Docket Item # 10 & 11 BAR CASE # 2015-00242 & 2015-00243

BAR Meeting September 2, 2015

ISSUE: Permit to Demolish/Capsulate & Certificate of Appropriateness

LOCATION: 201 S. Lee Street

1.03

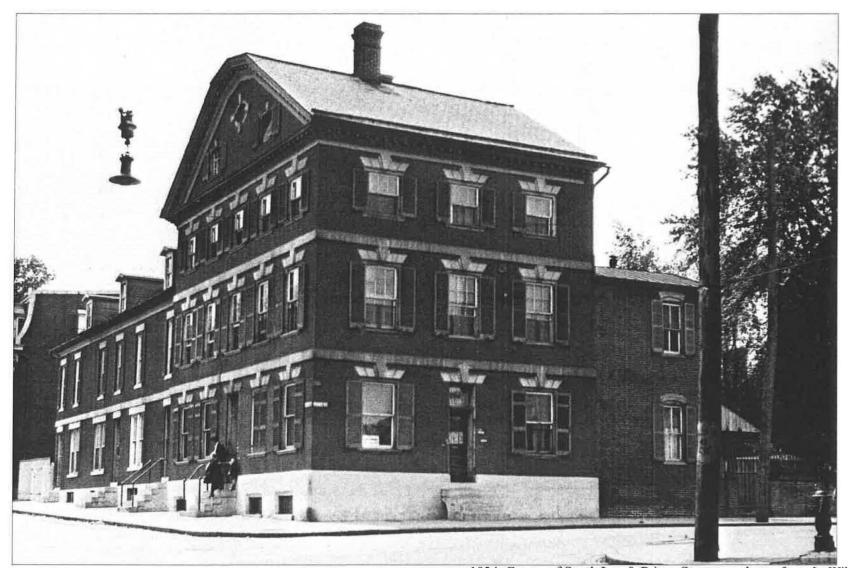
However, the proposed light configuration of the replacement windows does not appear to match what is shown in the historic photographs. Staff believes that the first floor double hung windows were nine-over-six and the attic windows were six-over-three (page 1.03) and that the glass sizes of the remaining windows should be adjusted accordingly in scale. Staff has inspected the windows, and the few Victorian-era windows that still remain on the house do not contain significant portions of wavy glass or unusual craftsmanship. The two-over-two window to be capsulated on the north elevation of the southern ell contains two panes of antique glass and the one-over-one windows on the east elevation contain none. Restoring the property to its 18th century period of significance would necessitate the removal of at least the one-over-one windows and staff supports this alteration. Staff recommends approval of the window replacement with the condition that the new windows comply with the *BAR Window Policy*, and with an appropriate muntin profile and light configuration.

- 1. That the final window specifications be submitted with a revised light configuration and muntin width for staff approval;
- 2. That the existing driveway gate be retained or the applicant return to the Board with a comparable replacement;

4.04

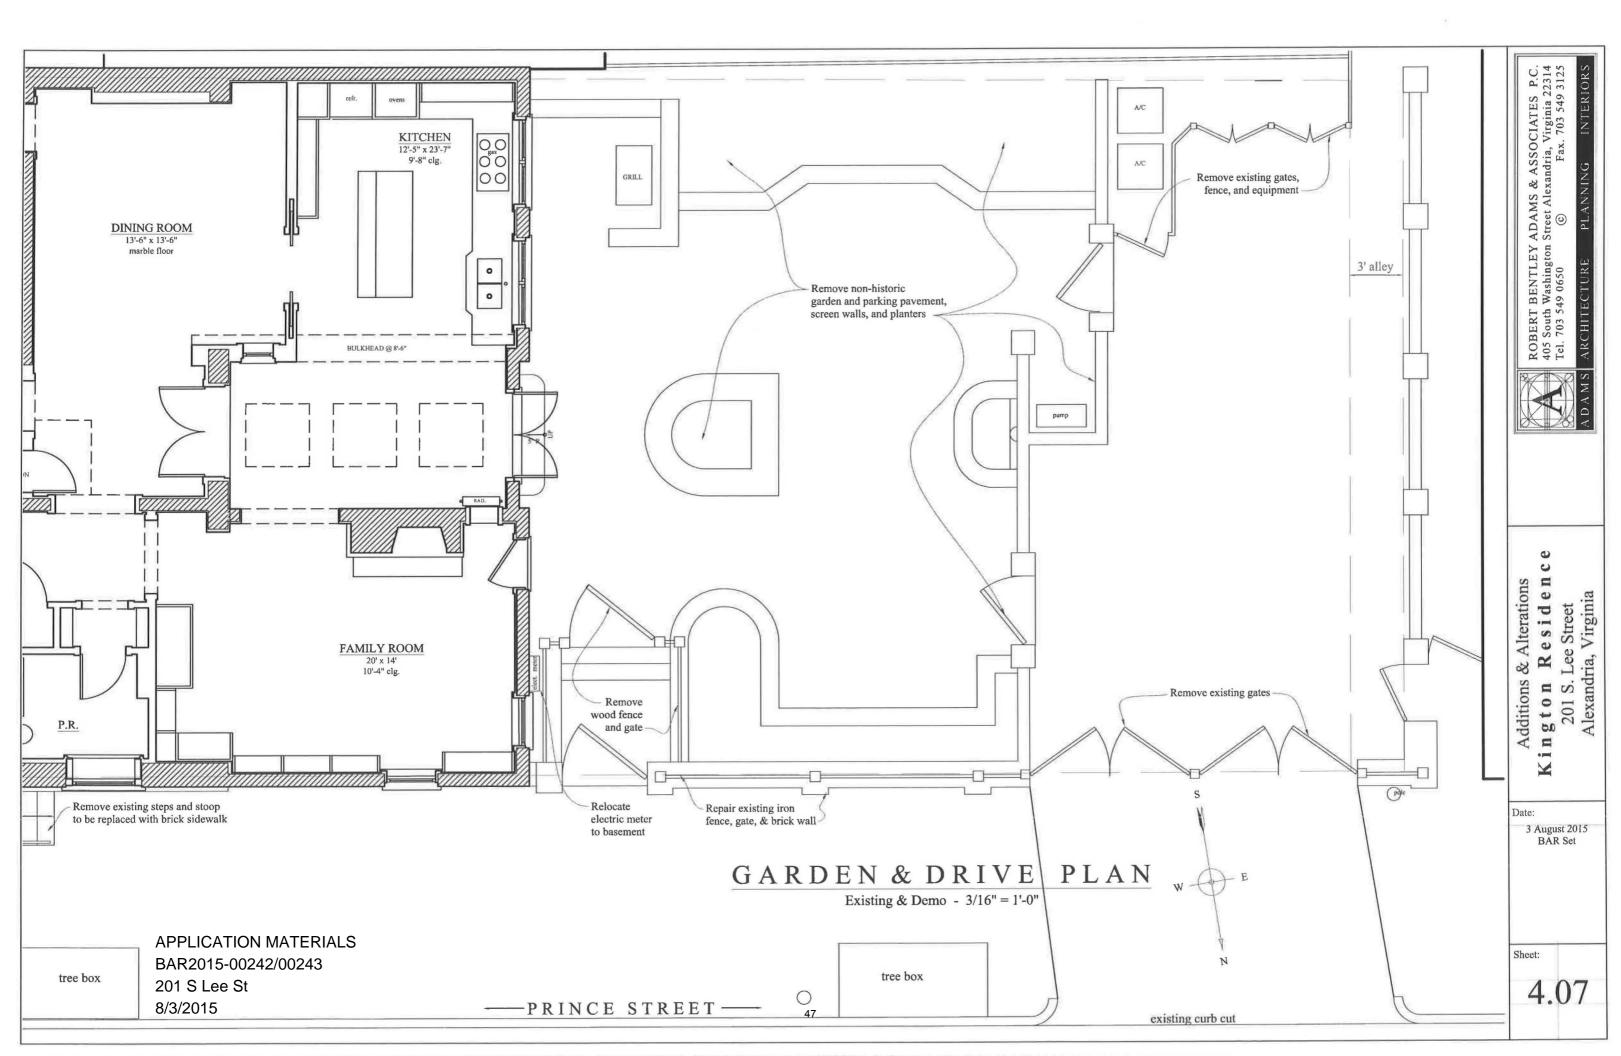
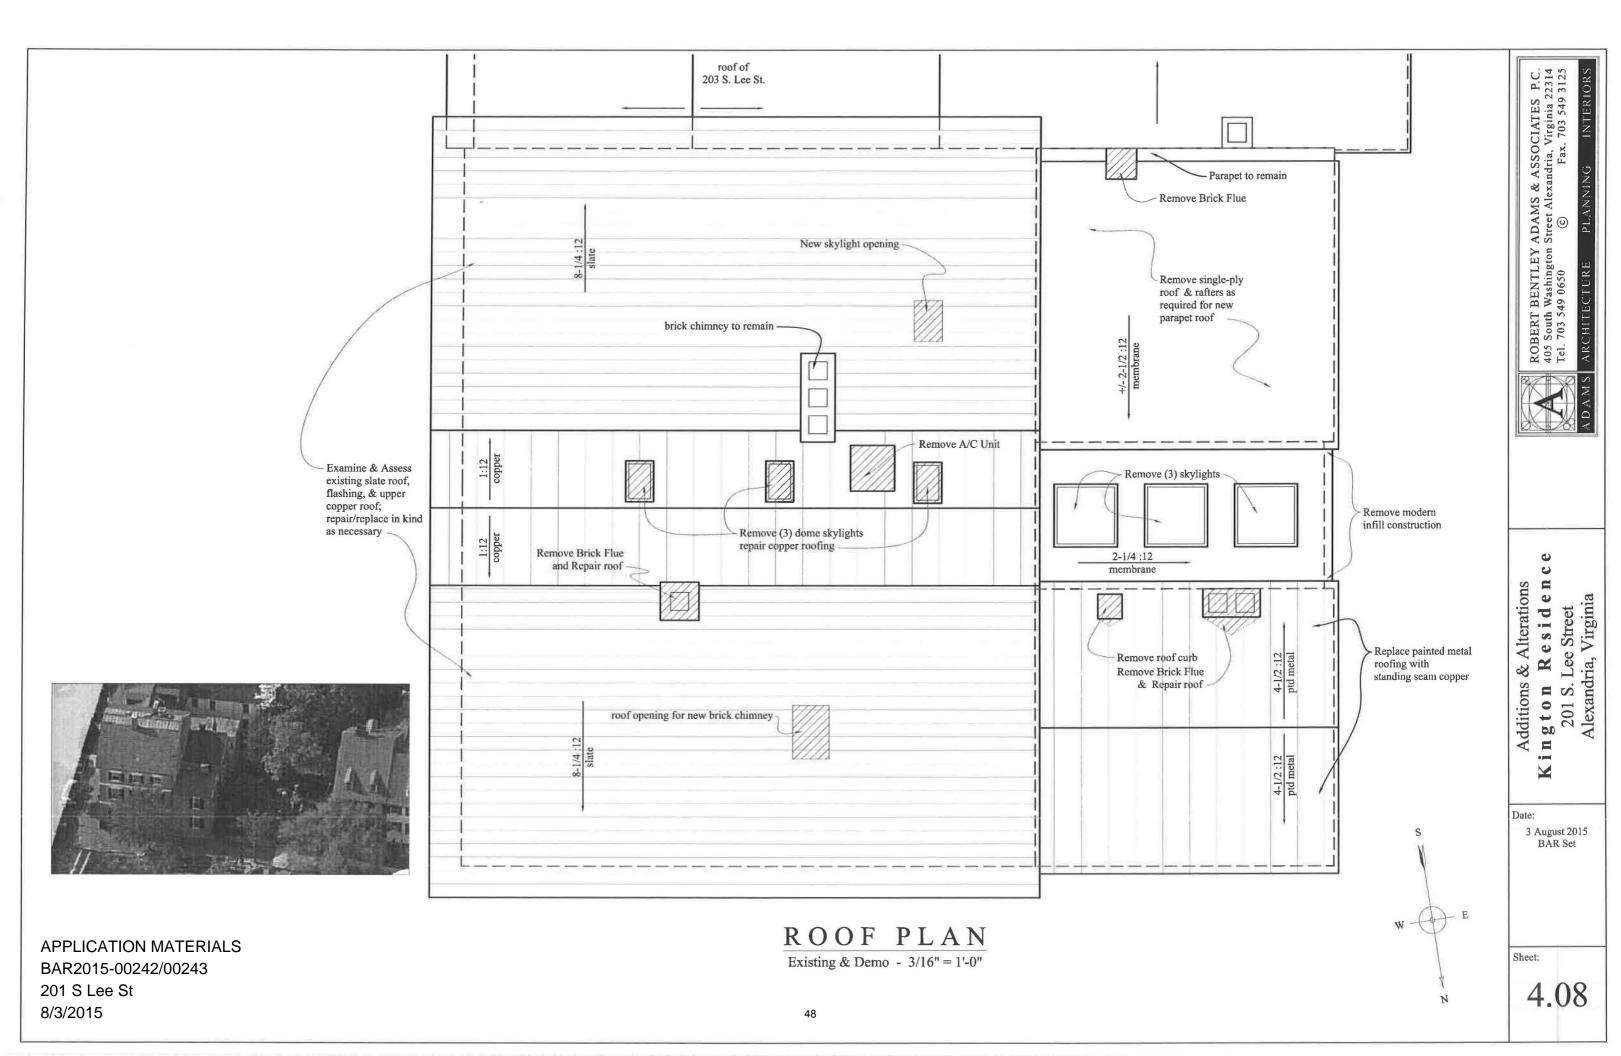
- 6. Build a new brick-faced chimney on the north slope of the main block (page 3.02)
- 7. Remove a brick flue (page 4.02)
- 8. Remove three existing domed skylights (page 4.04)

- 9. Install a new low-profile skylight (confirm) on the south slope (page 4.04)
- 10. Install three new basement level windows on the north elevation (page 3.02)
